PD Modification Application:

MM 25-0920

1.0 APPLICATION SUMMARY

PD 21-0560 was approved in 2021 to allow the property located along the north side of Brian Road to be developed for multi-family use with up to 97 dwelling units. The applicant is requesting a modification to allow the property to be used for a four-story parking facility.

2.5 Proposed Site Plan (partial provided below for size and orientation purposes. See Section 8.2 for full site plan)

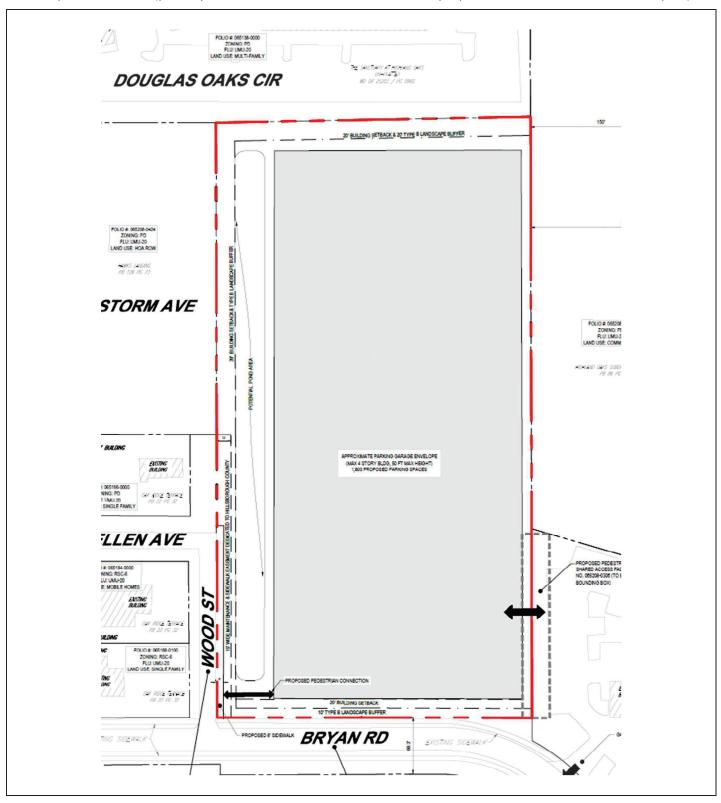
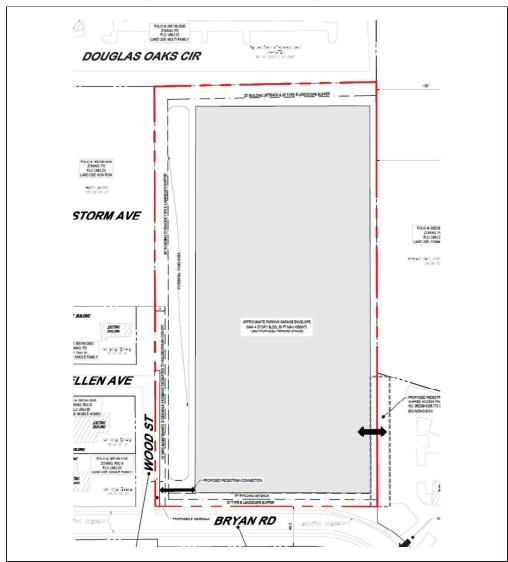
- 6. The project shall be <u>served by and limited to one accessed Vvehicular and pedestrian</u> access <u>connection to Highland Manor Drive through adjacent Folio 65208.0306</u> shall be <u>from Bryan Avenue</u>.
- 7. Developer shall construct a new sidewalk eight feet from the eastern edge of pavement of the segment of Ellen Ave running north from its intersection with Bryan Road until it turns westward as depicted on the site plan. Developer shall provide at least 2' of clear area east of the sidewalk.

The approved PD permits vehicular access to Bryan Road. This PD modification requests to remove that access connection and proposes its sole vehicular access to Highland Manor Drive through Folio 65208.0306 to the east.

25-0920

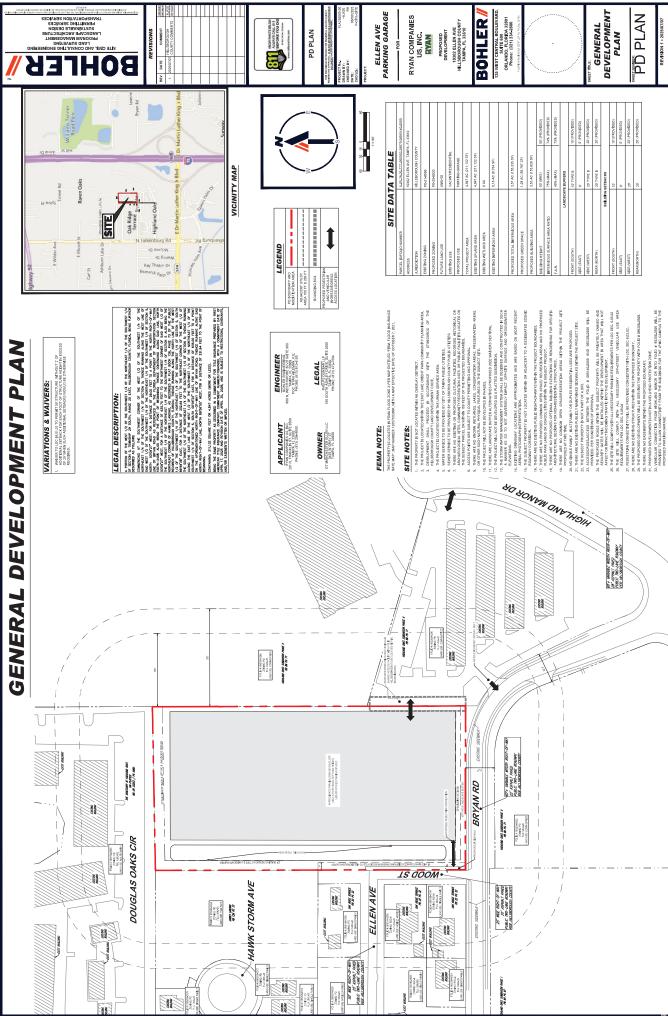
- 1. Identify the variation from LDC Section 6.05.02(D)(2) in the Variations & Waivers text box;
- 2. Change the waiver to §6.01.01 to a site note written as, "the 2' to 1' setback increase requirement of § 6.01.01 shall not apply for structures taller than 20 feet";
- 3. Change the north setback to 30' in the callout and in the setback summary table;
- 4. Change the east setback to 10' in the callout and in the setback summary table;
- 5. Revise the western notation of "20' Building Setback & Type B Buffer" to "20' Buffer with Type B Screening"
